Stormwater Management/BMP Facilities
Record Drawing/Construction Certification
Review Tracking Form

County Plan No.: Pointe at Jamestown Phase I-C
 Project Name: S-65-99
 Stormwater Management Facility: WETPOND, SIR GILBERT LOOP (BEHIND LOT 88 GRU-C, 4671 SIR GILBERT LOOP)
 Phase: I II III

RECORD DRAWINGS
THE POINTE AT JAMESTOWN, PHASE 1-C
STORMWATER DETENTION POND

Re: The Pointe at Jamestown, Phase 1-C
County Plan No. S-65-99
Stormwater Management Facility
County BMP ID Code: PC 148

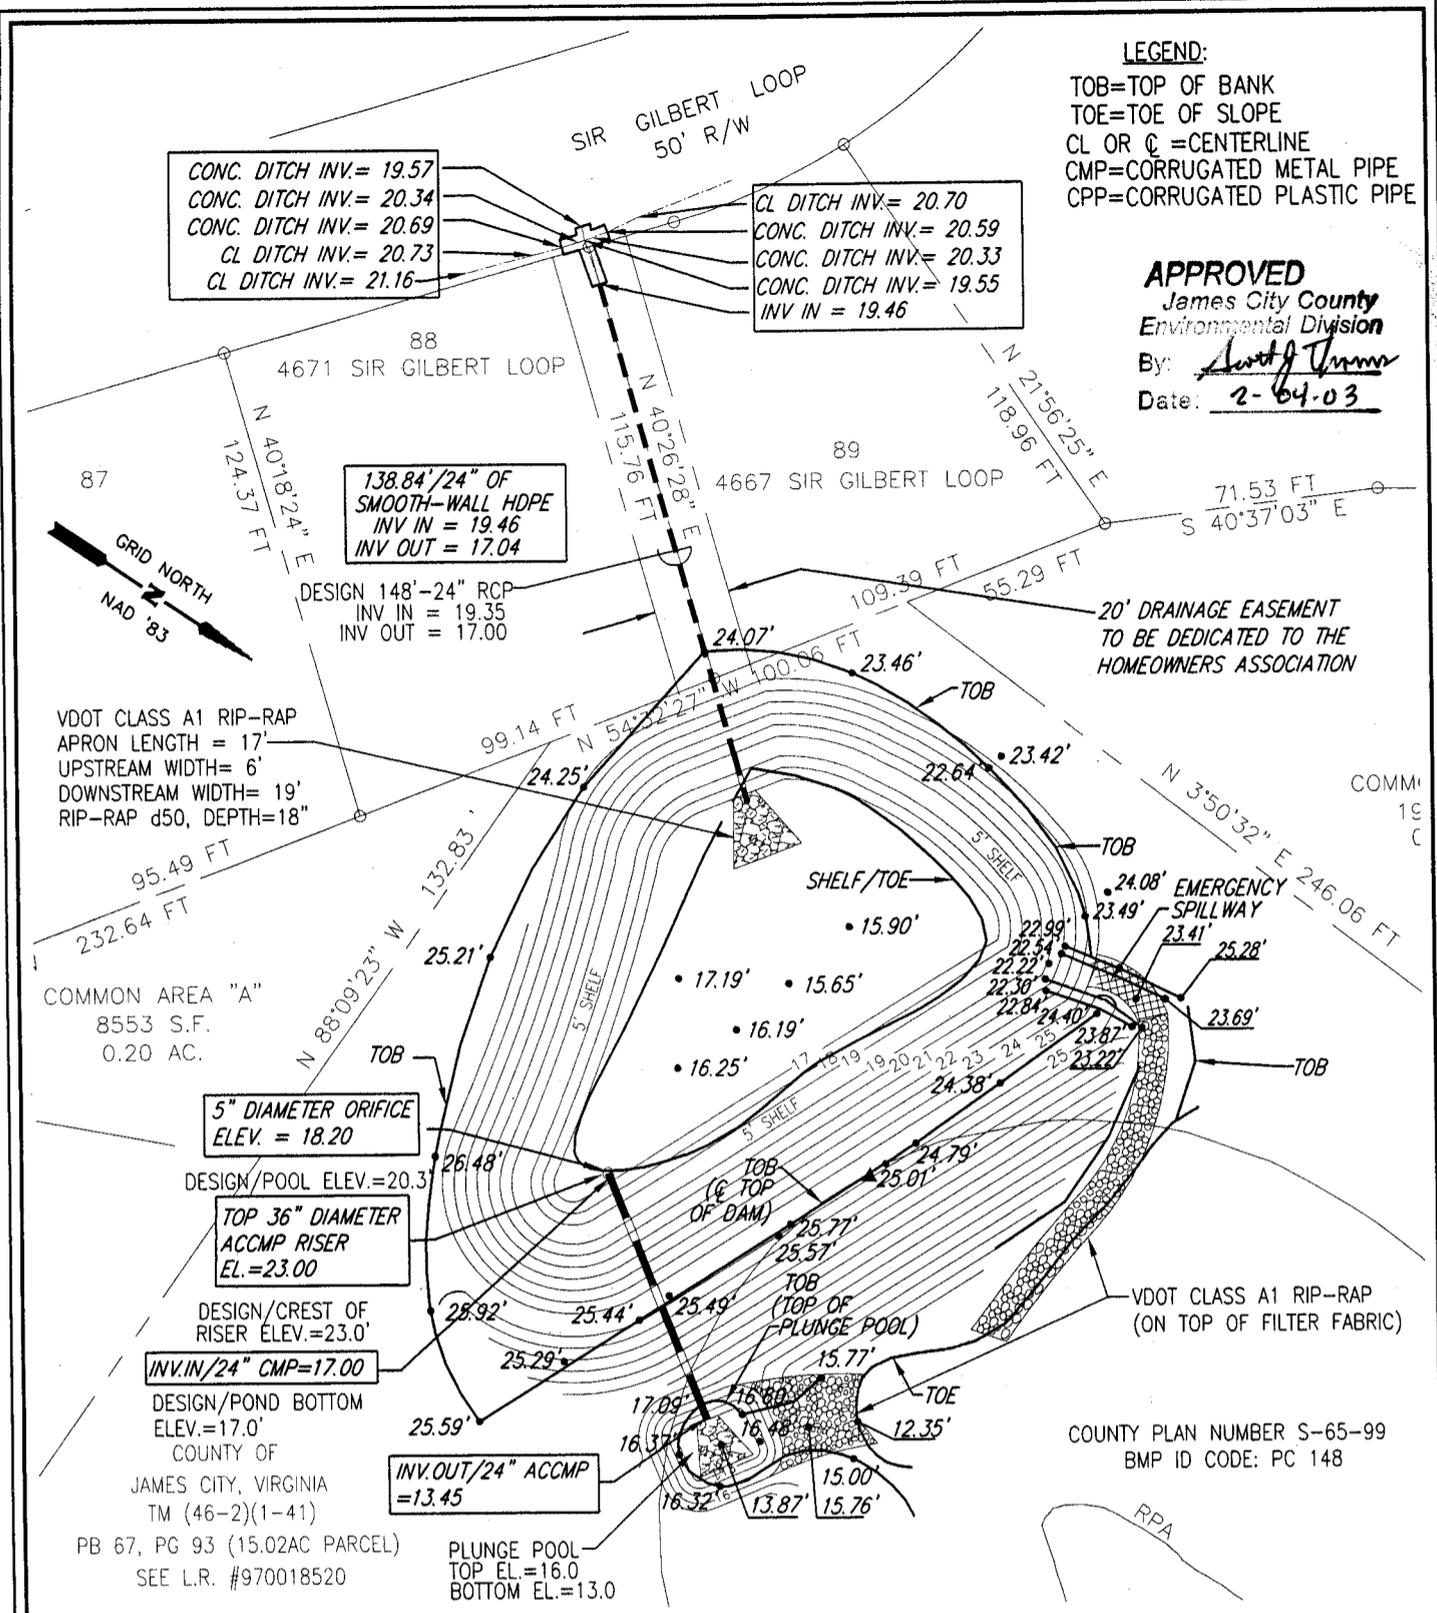
1. SLIGHTLY LOW SPOT GRADE ON DAM CREST=24.38 (25.00=DESIGN).
2. ~~BARREL OUTLET END SECTION PARTIALLY DAMAGED/COLLAPSED.~~ REPAIRED.

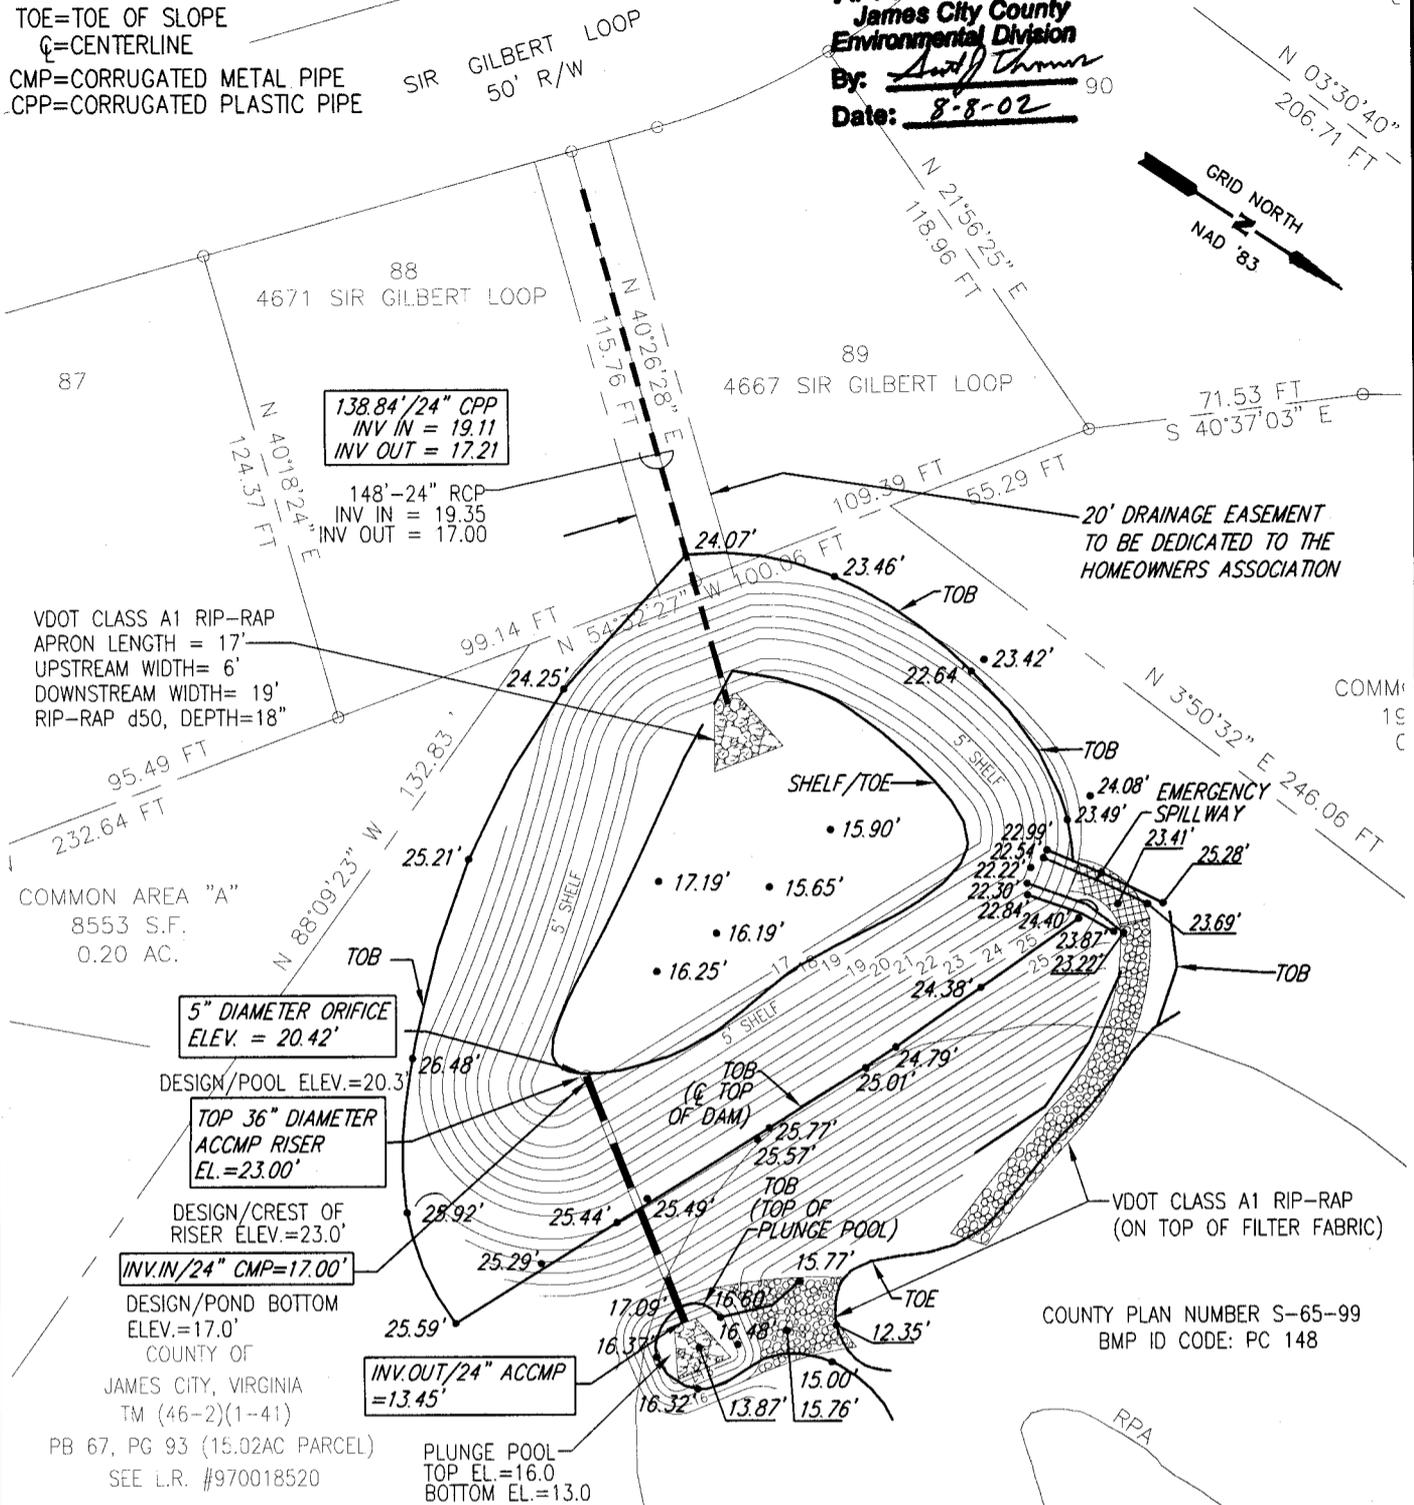
1. SLIGHTLY LOW SPOT GRADE ON DAM CREST=24.38 (25.00=DESIGN).
2. BARREL OUTLET END SECTION PARTIALLY DAMAGED/COLLAPSED.

COMMISSION NUMBER
1980102
SHEET NUMBER
C7
8 OF 12

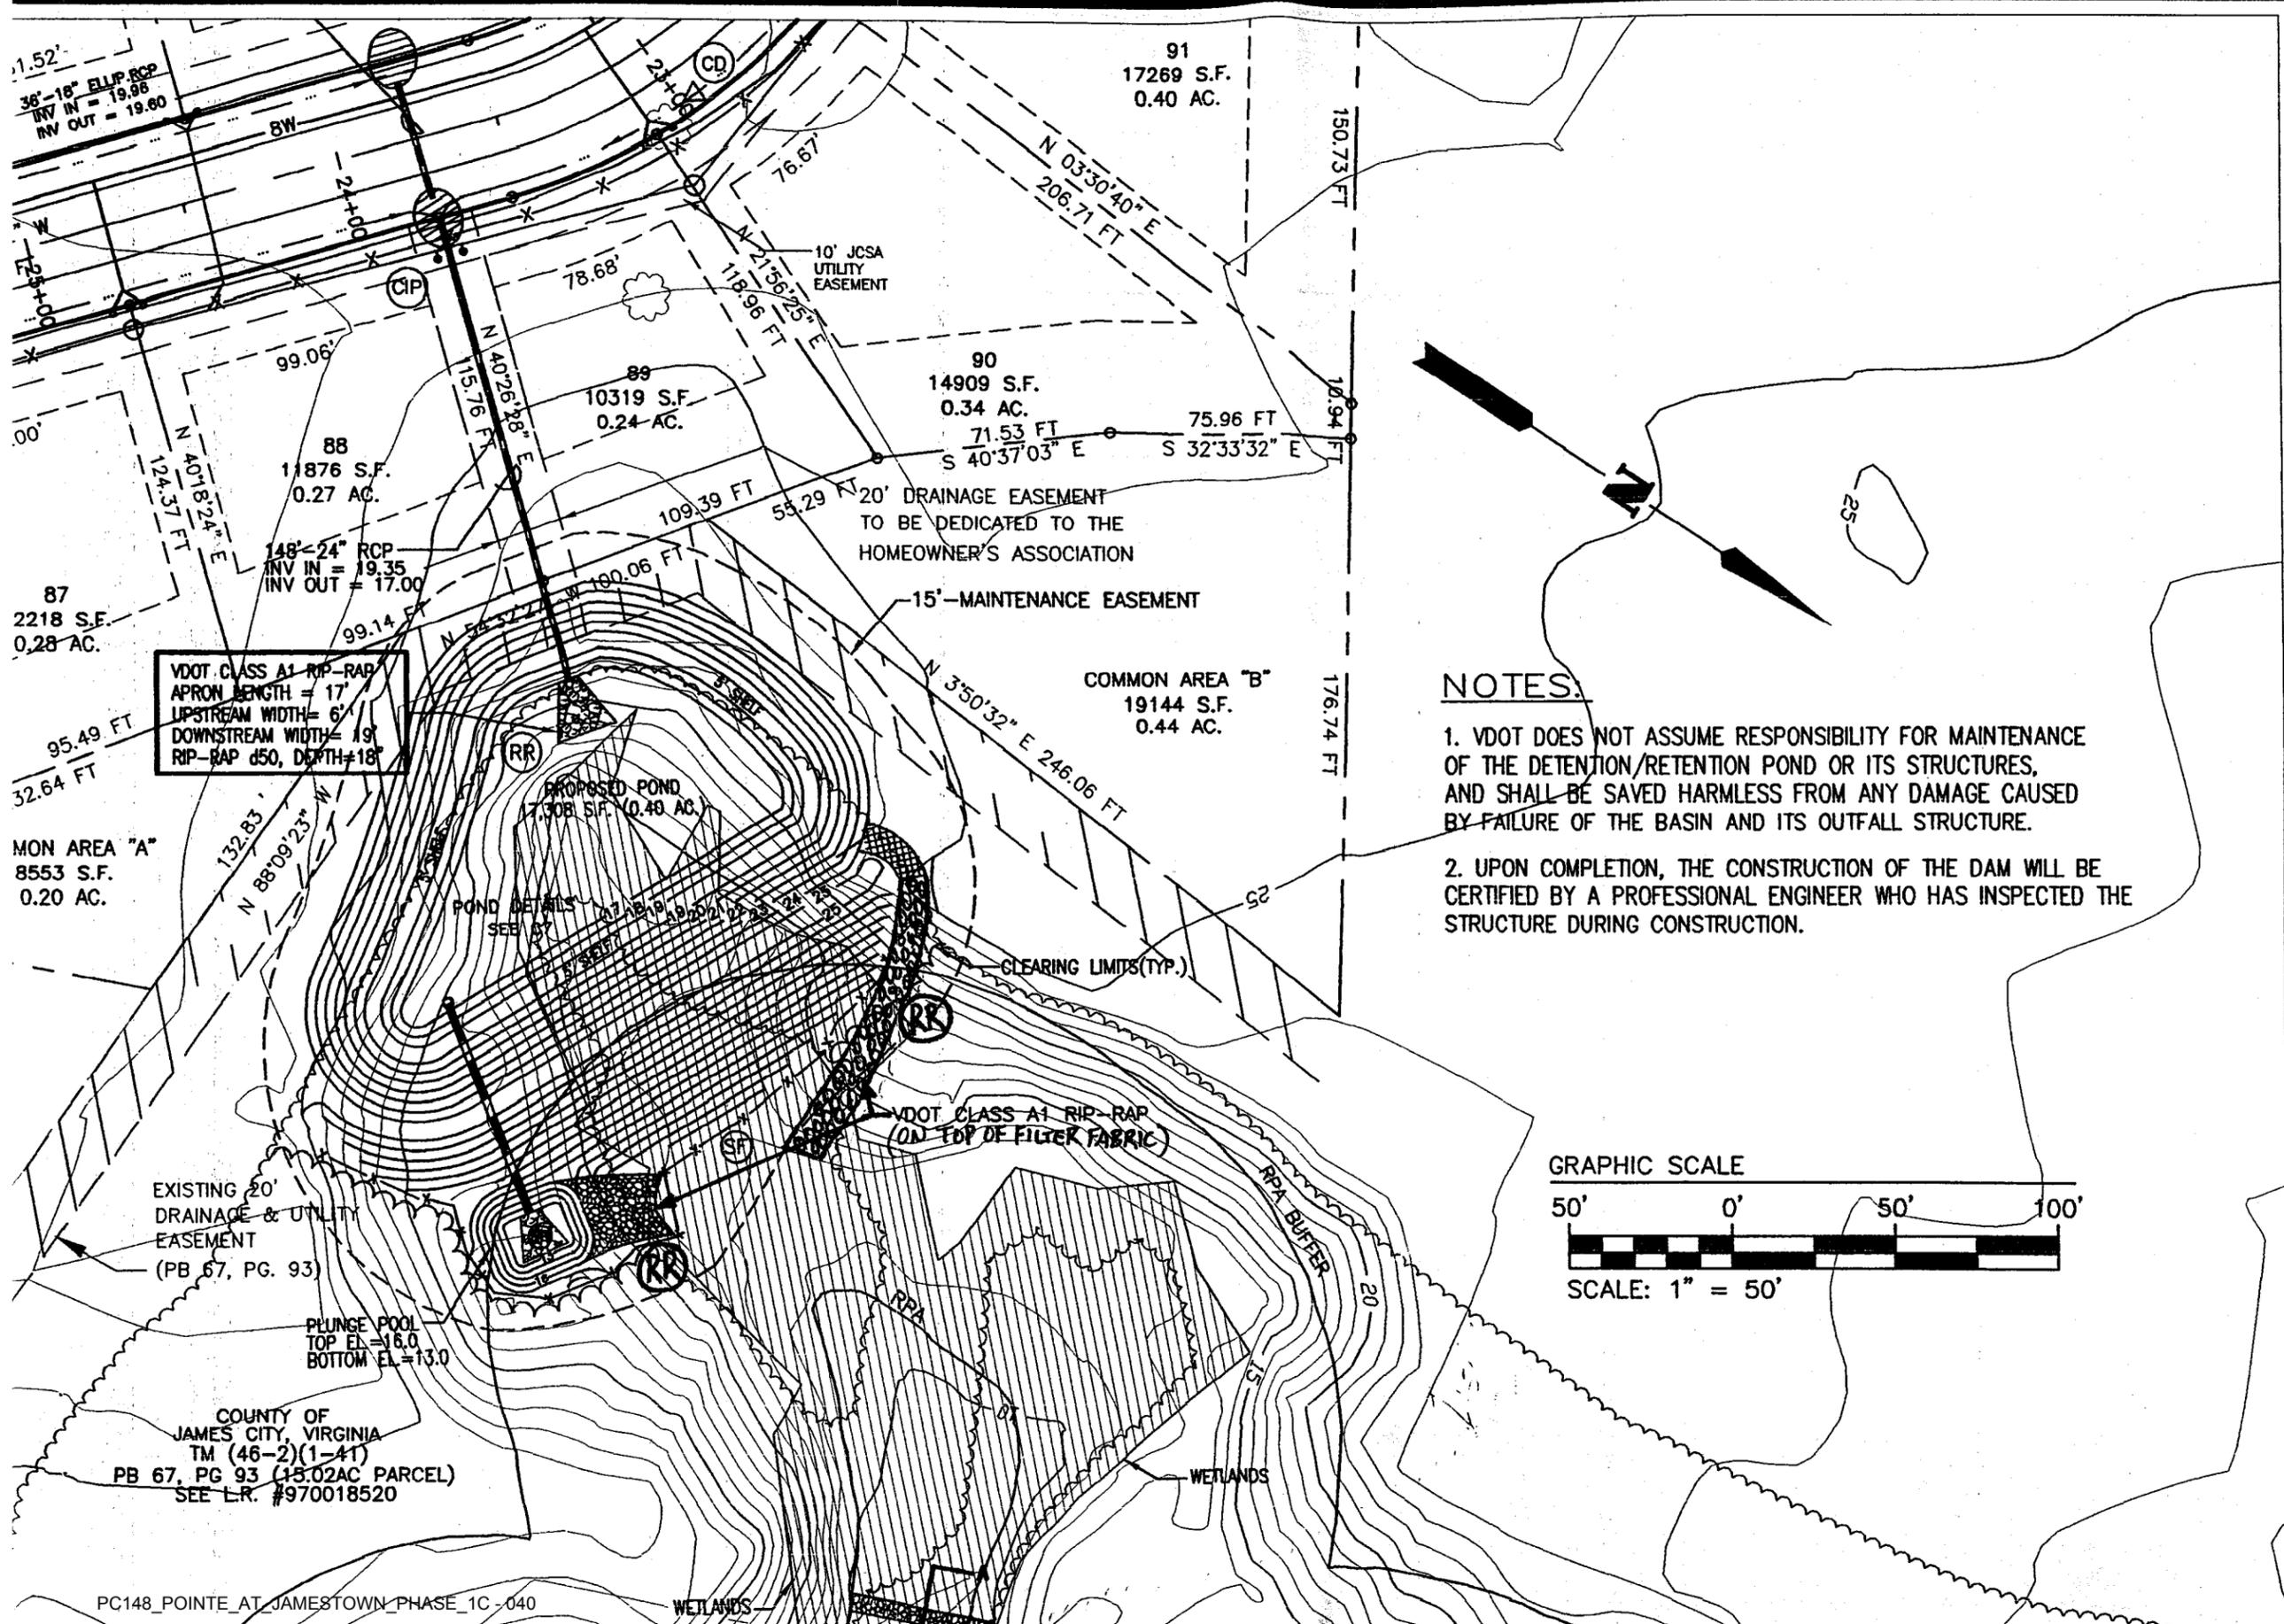
1. Note # 19 on Sheet C-7 and Note # 2 on Sheet C-4 of the approved plan required construction certification for the stormwater management/BMP facility. None was provided. This is especially important since the facility has an engineered and compacted earthen embankment. The certification can be in letter format or by use of the certification statements in Section 4 of the *James City County, Stormwater Management/BMP Facilities, Record Drawing and Construction Certification, Standard Forms & Instructions*.

8. Identify any off-site land disturbing areas required with proper erosion control measures.
9. Replace the Erosion Control Notes on sheet C-7 with the revised James City County Erosion Control Notes dated 5/5/99.

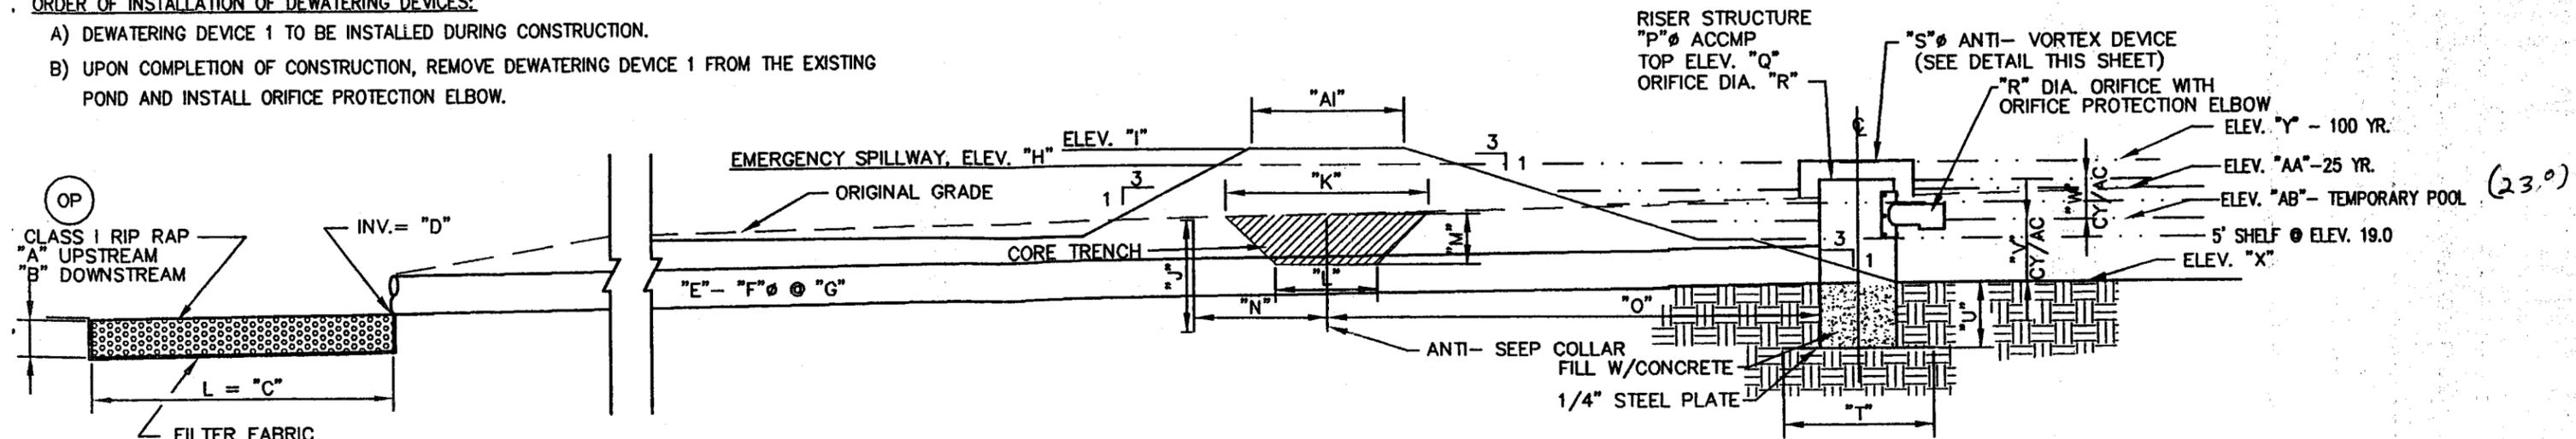
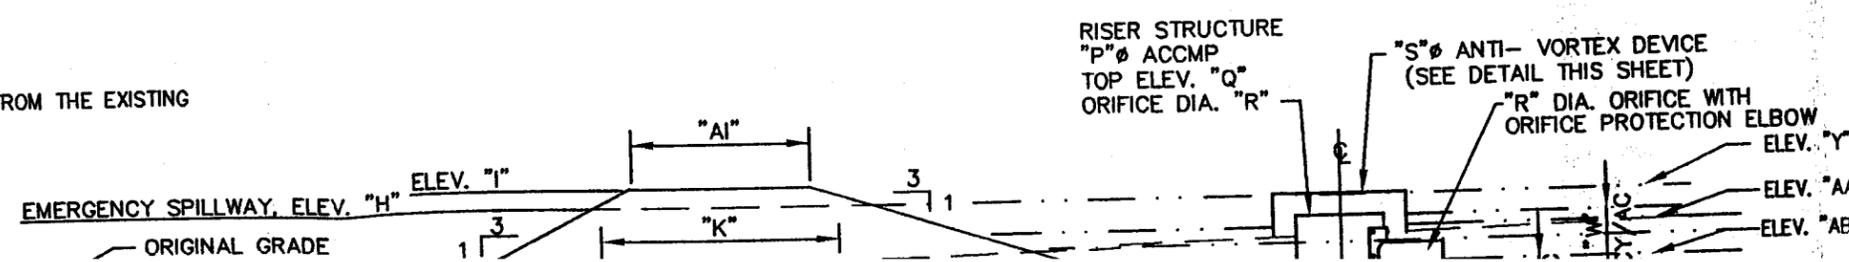
- B. The dam detail on sheet 7 calls for the riser structure to be ACCMP, while the dewatering device 1 detail on the same sheet calls for CMP pipe. CMP is not acceptable for use in a permanent BMP.

*ALUMINIZED PIPE
TO REPLACE ACCMP
11-13-99*

ALUMINIZED PIPE TO REPLACE ACCMP 11-13-99
